AGENCY COORDINATION

Sample Early Coordination Letter

Subject: US 50 North Vernon Bypass—East
Designation # 1173374
Early Coordination Initiation
Jennings County, Indiana

US 50 EAST BYPASS
Figure 3b - Water Resources
Early Coordination Letter

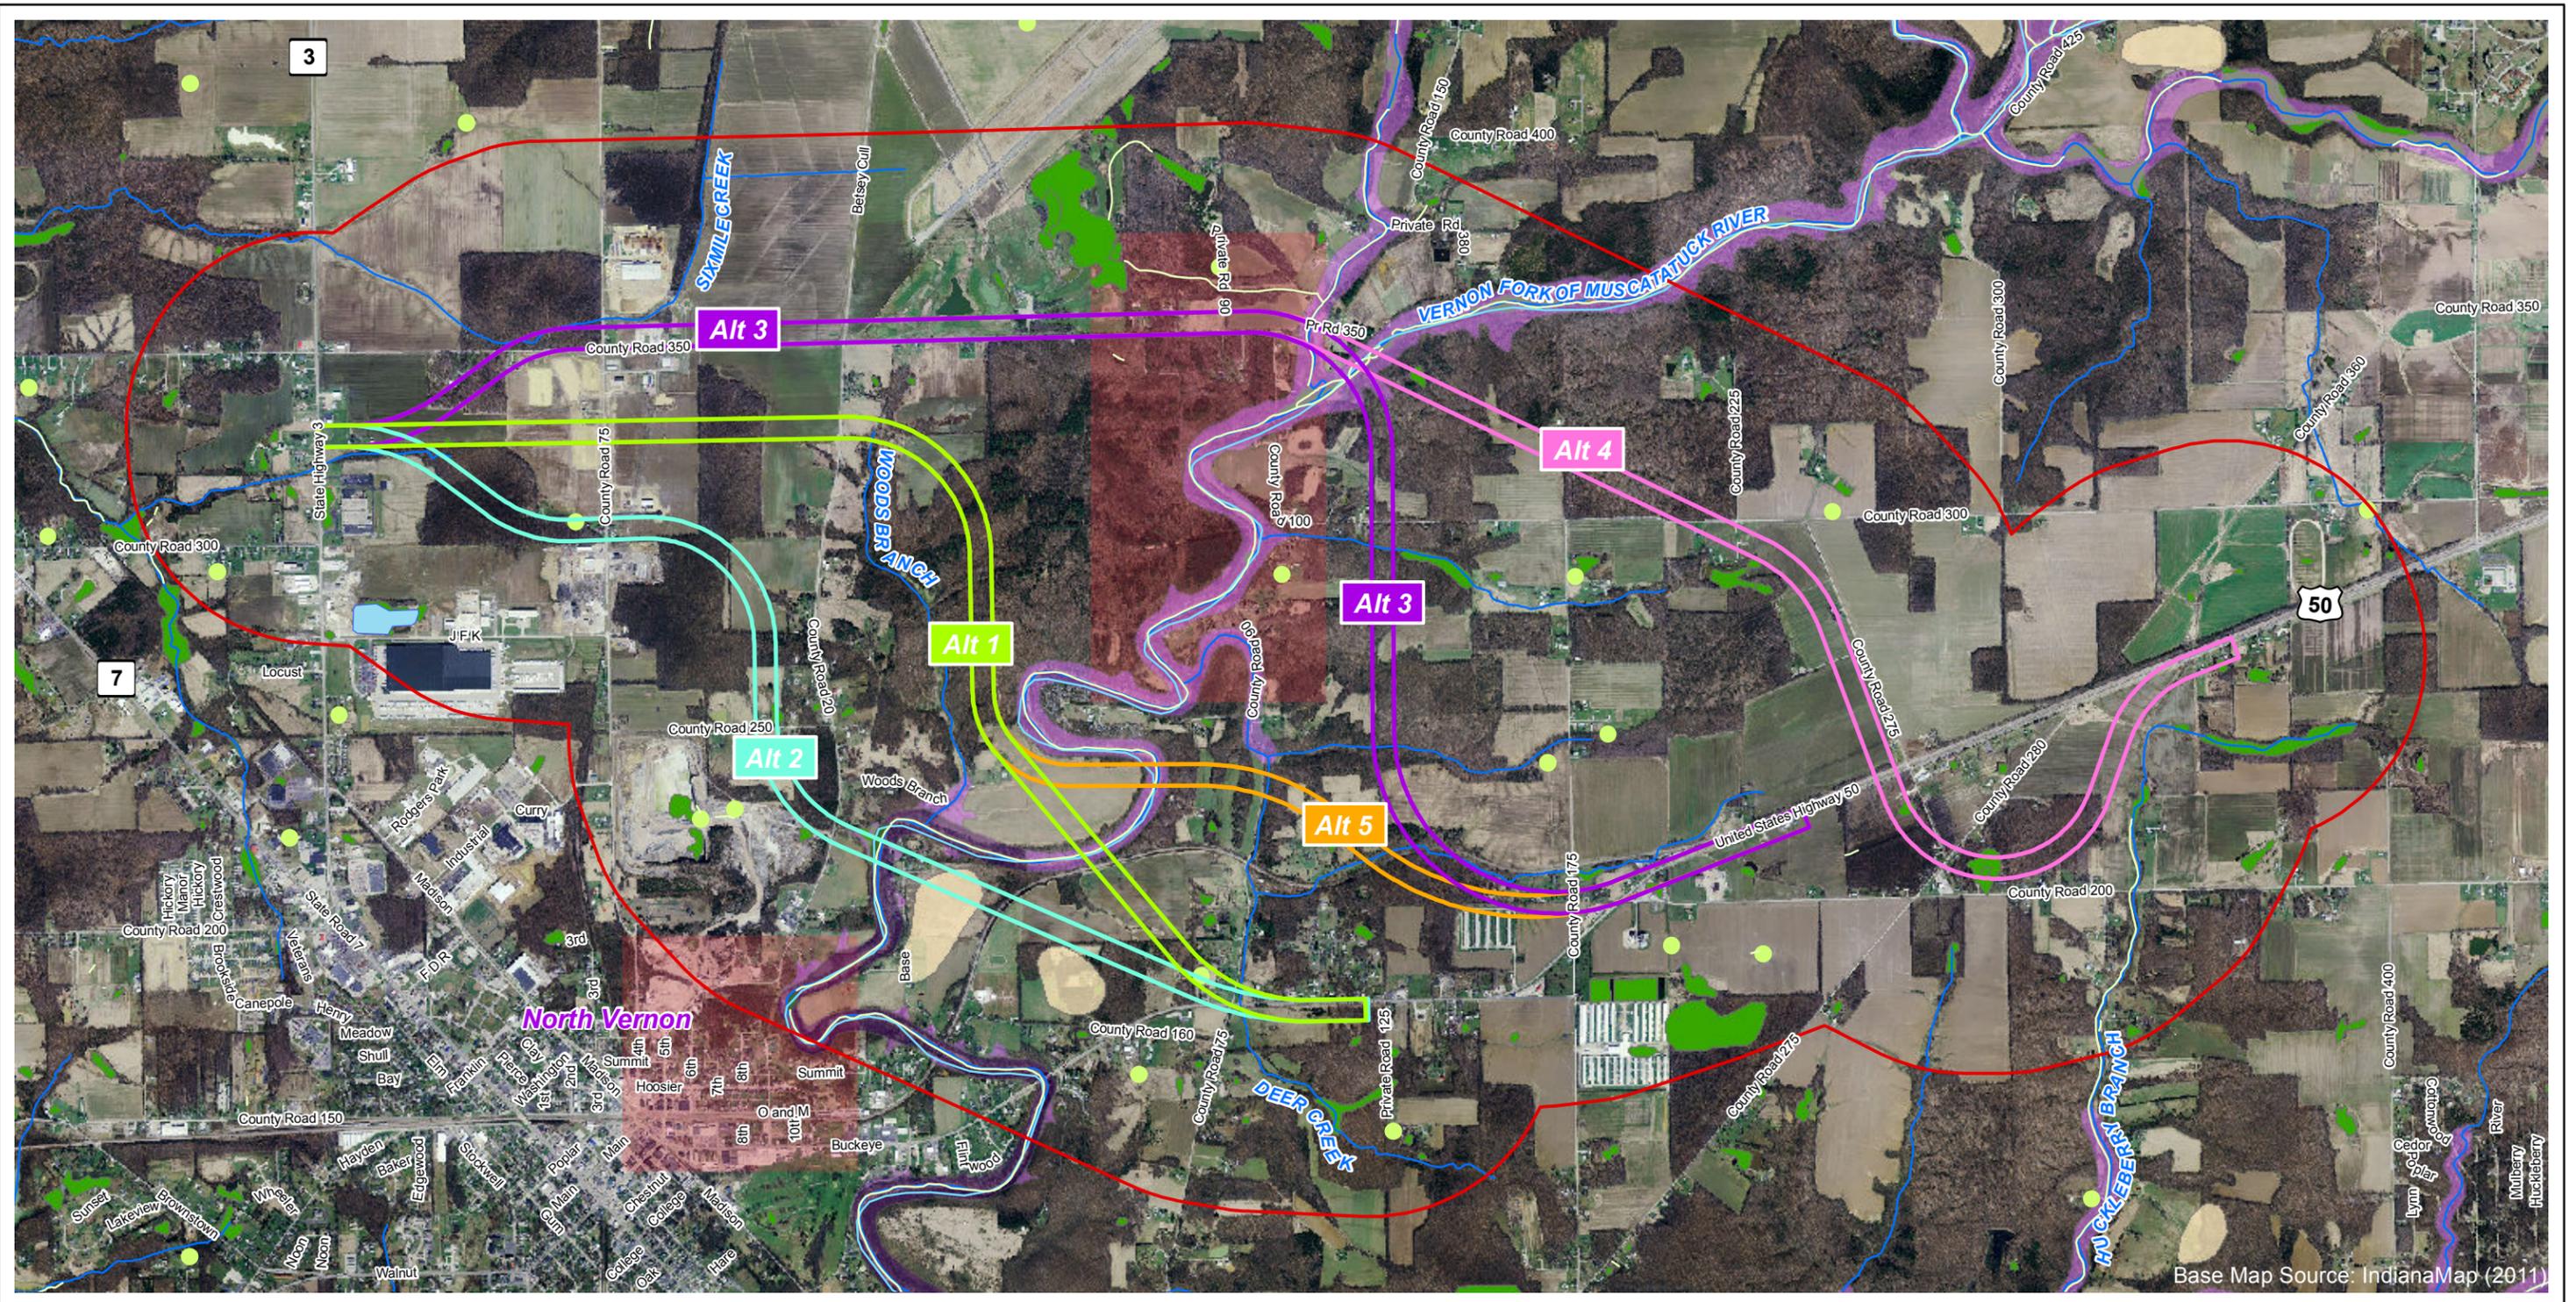
Karst: *Figure 3b – Water Resources*, identifies, in part, the location of karst features (cave entrances, sink hole areas and sinking stream basins) in the east bypass study area and the preliminary route alternatives. It appears that portions of all five preliminary alternatives are located in karst terrain and have the potential to impact resources associated with karst topography. Have karst investigation studies been undertaken in the east bypass study area since the 2008 study? Do you have adequate information to confidently identify the preliminary alternative routes that will have the lowest potential to impact resources associated with karst geology? We recommend the NEPA documentation include an assessment of each preliminary alternative to impact the surface water and groundwater quality and quantity (including public and private drinking water supply), and the wildlife associated with karst features in the study area.

Wetlands/Streams: *Figure 3b – Water Resources*, also shows the location of wetlands and streams in the study area. Are these field delineated wetlands? The U.S. Fish and Wildlife Service's National Wetland Inventory show at least four forested wetlands that might be impacted by the five action alternatives, some of which do not appear in Figure 3b or may have

Prior to the next resource agency meeting, please provide the resource agencies with additional wetland and stream information for the east bypass study area. Please provide the information in table and figure formats that clearly identify wetland and stream types, amounts, quality and locations in relation to the preliminary alternatives.

ALTERNATIVE 6-D
 US-50 BYPASS
 JENNINGS COUNTY, INDIANA

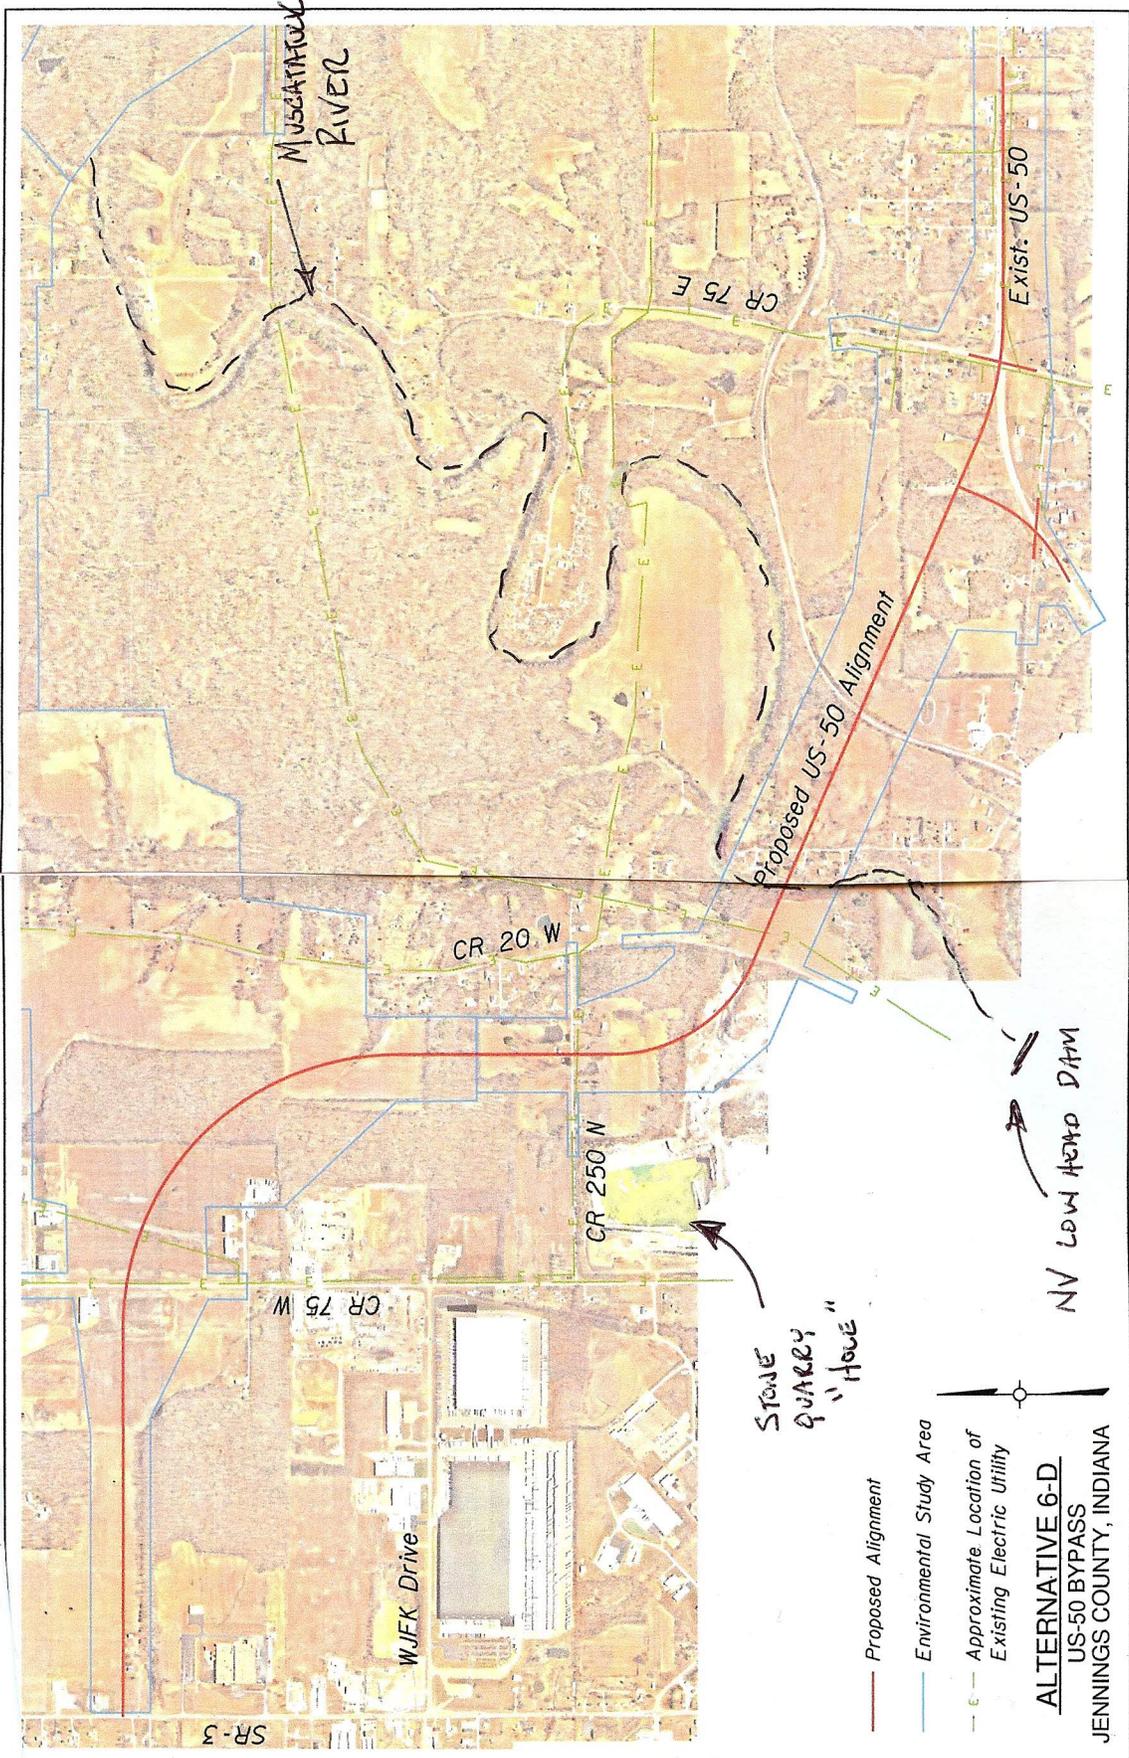
There was a recent early coordination meeting was held with various utilities that may be affected by the bypass alternate routes. Concerns were expressed by Mike Hess that the Alternative 6-D route was the closest to the City's water intake and that the potential of significant harm could result from an accidental or intention spill in their impoundment. A subsequent conversation with the consultant has indicated that the consultant plans to recommend Alternate 6-D to INDOT as the recommended project.

The attached maps provide the location of the alternate routes and the relative proximity to the City's low head dam. The location of alternate 6-D is approximately 2600 feet (stream length) from the low head dam while the alternative 4 is 20,900 feet stream length from the low head dam. This places alternative 4 as 3.5 miles farther away from the dam as alternative 6. There are no existing road crossings of the Muscatatuck River for approximately 9 stream miles from the dam.

Typically, "time is of the essence" when dealing with spills that could migrate. The close proximity of Alternate 6-D to the intake may not provide sufficient time between a spill and it reaching the intake prior to the water plant being notified. Whereas, at least, Alternate #4 provides more time to notify the water plant, in which the intake could be shut down prior to the spill reaching the intake.
